20 September 2024 Our Ref: 23GCT0211-LT02

RE: 10 Grand Parade, Casuarina Specialist Medical Centre- Response to Information Request

TTM has been commissioned to conduct a traffic assessment for the proposed development at 10 Grand Parade, Casuarina. This letter addresses the Information Request from the Department of Planning, Housing, and Infrastructure concerning the site. It is understood that additional assessments of traffic, parking, and site access are required.

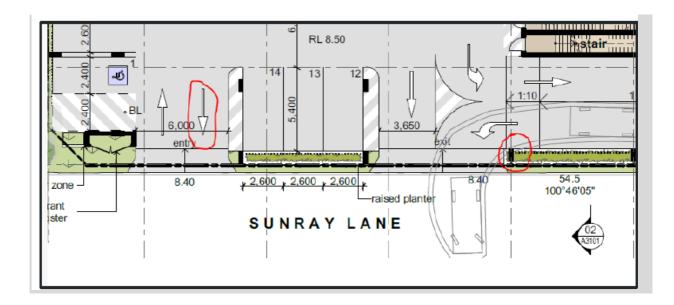
The manoeuvrability of vehicles travelling in, out and within the parking area is unclear. Swept path diagrams are to be provided with the following at a minimum:

- Detail of Sunray Lane in full including the verge and any significant details of the dwellings to the south that may impact on the manoeuvrability of vehicles.
- All possible vehicle movement when entering and exiting from Sunray Lane e.g., left and right-hand turns from Sunray Lane into the site.
- Access into and out of accessible parking spaces Nos. 1 and 11 and other spaces at corners and junctions.
- Inconsistencies corrected as per the below image marked up in red.

Note: All swept paths, including clearances, shall be free of obstruction and not result in any conflict with oncoming traffic.

• The identified inconsistencies in the site plan, such as the incorrect directional arrow in the western access driveway and the landscape kerb at the edge of the exit driveway, have been corrected in the revised site plan shown in Appendix A. Figure 1 illustrates the corrected directional arrow in the western access driveway and the shortened landscape kerb at the edge of the exit driveway.
